Project # 5015097

RFI #: 0104

SHCE DP#3 - MRI Room Corner Wall Conflict with Existing Column Fireproofing

8 2ND FLOOR PERIMETER DETAIL @ GL 6 - B
SCALE NTS

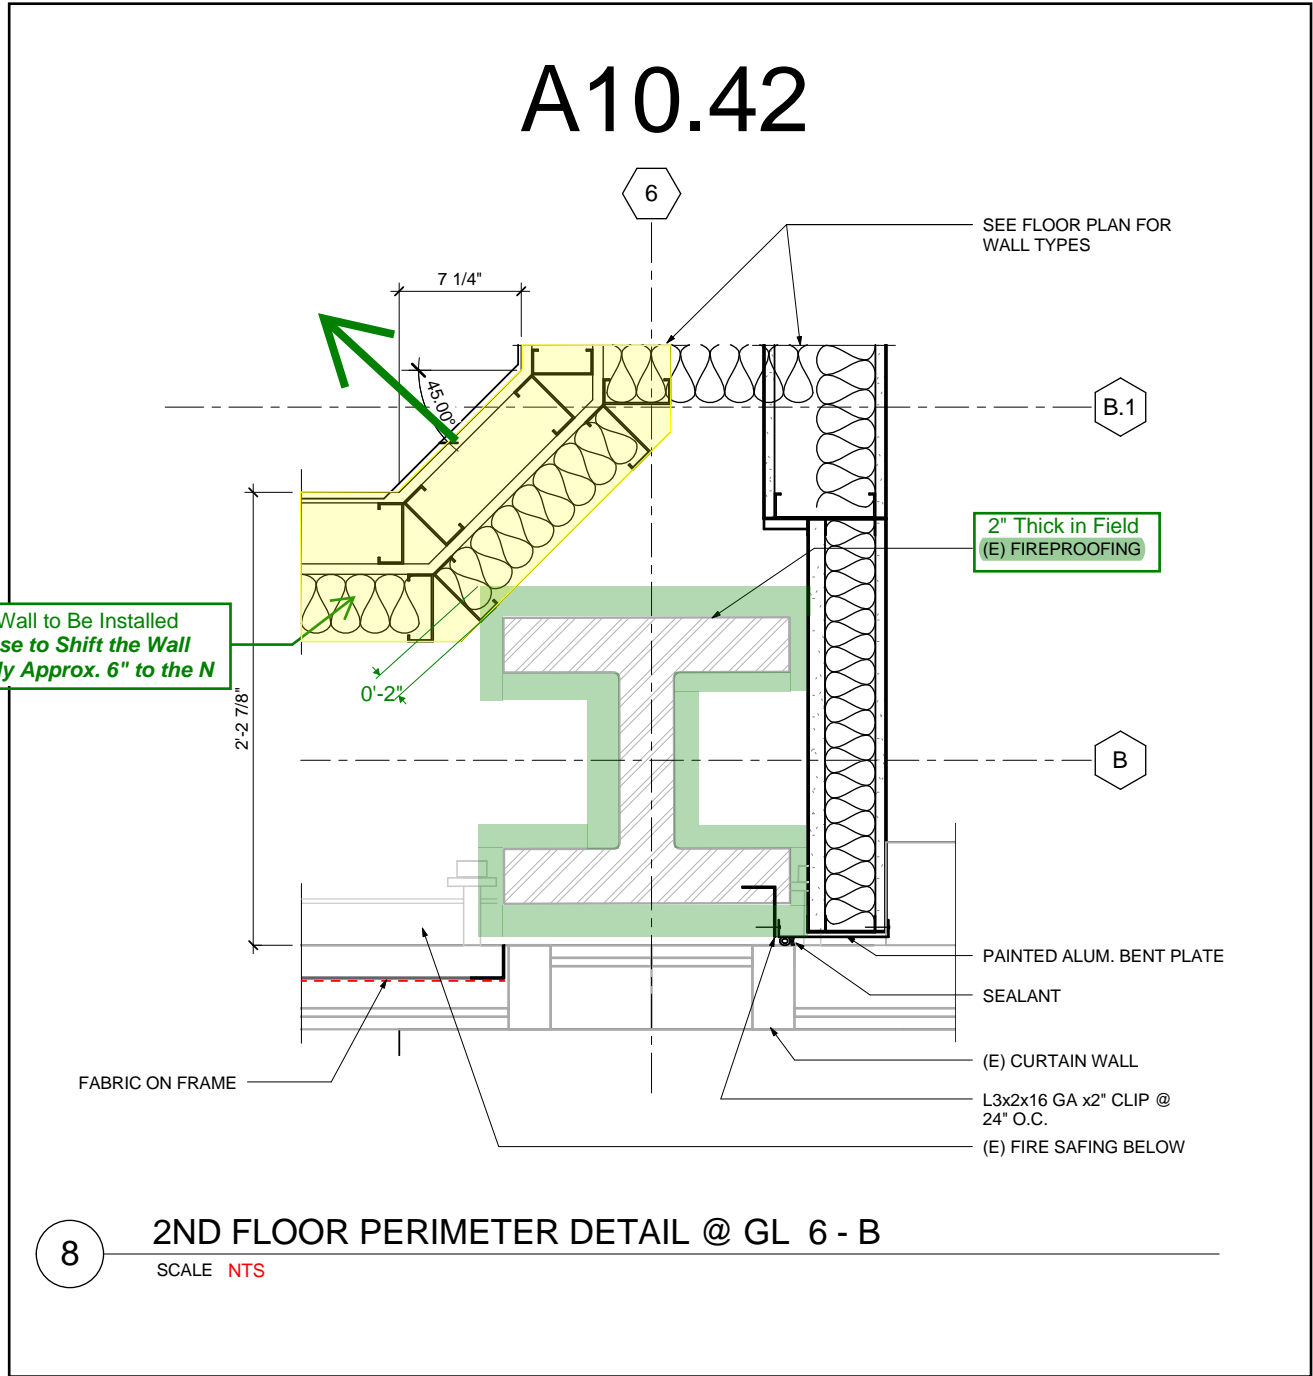
As shown in the attached sketch, the existing structural column illustrated within Detail 8/A10/42 has a 2" thick coating of fireproofing which conflicts with the designed layout of the new wall assembly.

Per a field walk between Brendan Miller (Hensel Phelps) and Ryan Denny (KMB Architects) on 1/26/2016, it was agreed that the wall assembly could be shifted approximately 6" further into the room (north) in order to correct the conflict.

Please confirm.

New Wall to Be Installed
Propose to Shift the Wall
Assembly Approx. 6" to the N

Confirmed.
